Overlook Walk & Seattle Aquarium

Meeting Summary

April 19, 2018

Concept Design

Figure 3: Proposed design - Bluff Walk

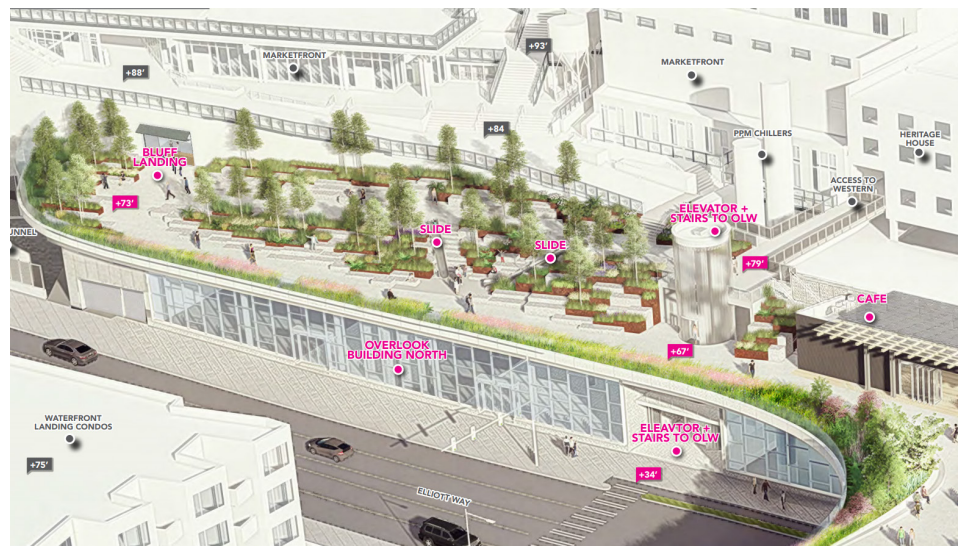
The SDC encouraged the project team to think about how the design of the Bluff Walk can evolve from serving primarily as a pathway to becoming a series of spaces between the Marketfront and main Overlook Walk area. Commissioners then encouraged the project team to explain how the current design was influenced by lessons learned from the design and construction of the Marketfront. The Commission then emphasized the importance of vegetation. Commissioners commended the design team for the amount of vegetation along the Bluff Walk and encouraged the design team to increase the amount of vegetated areas, if possible.

Figure 4: Proposed design - Overlook Walk Bridge

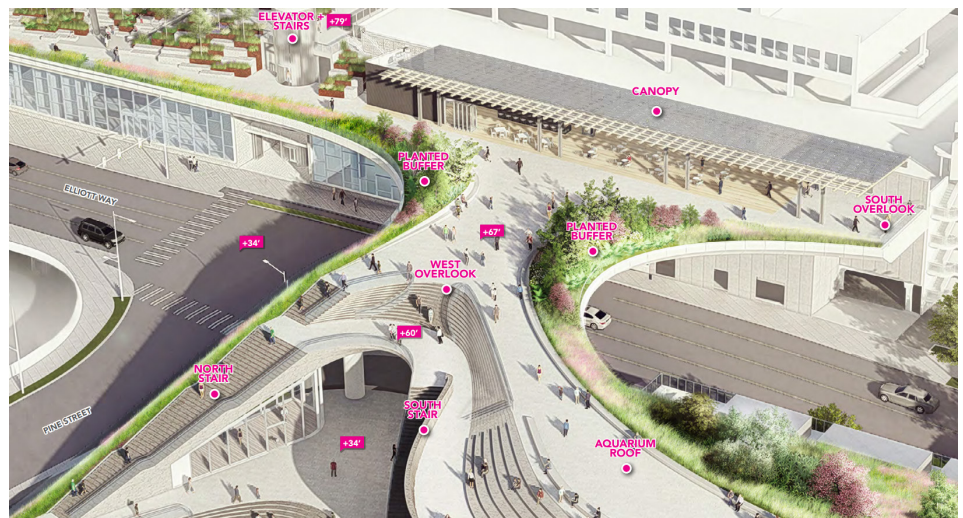
The SDC supported the narrowing of the bridge and agreed the reduced width would still provide adequate gathering space. Commissioners encouraged the project team to reconsider the height of the proposed plantings along the bridge, which currently obstruct views to the north and south.

Figure 5: Proposed design - Bay Steps

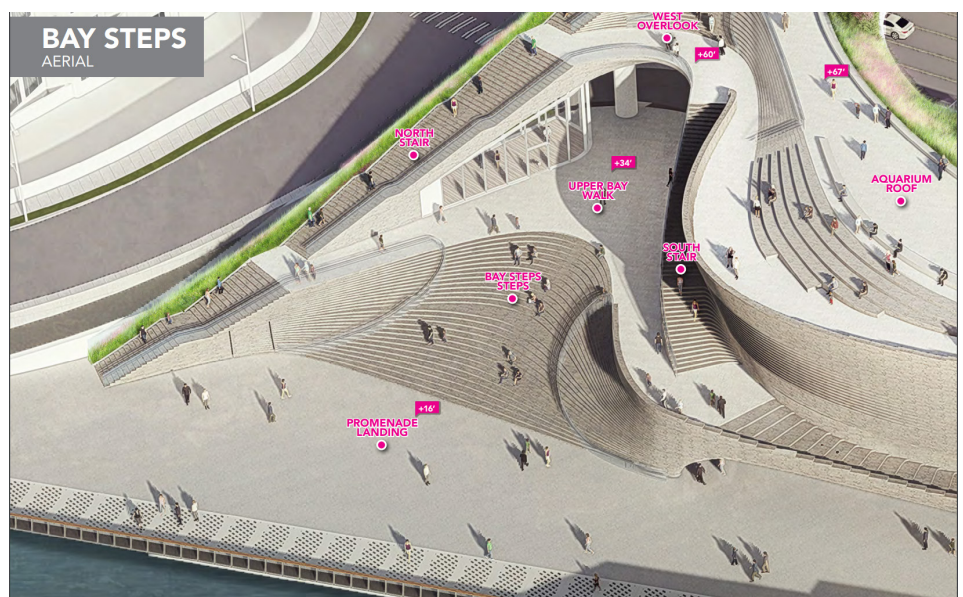
While the SDC commended the project team for the form and curvilinear design of the Bay Steps, several commissioners voiced their concern with the areas located on either side of the Bay Steps between the stair railing and wall. Commissioners questioned how these spaces would be used, if it is occupiable, and maintained long-term. Commissioners then commented on the location, material, and functionality of the stair railing, which serves a barrier to the overall design of the Bay Steps. The commission strongly recommended the design team to address these issues as the design develops while maintaining the strong curvilinear design.

10. Further analyze the areas outside of railings on the Bay Steps as the design develops while maintaining the strong curvilinear design.
11. Integrate or screen the mechanical equipment on the roof of the Aquarium facility, to the greatest extent possible.
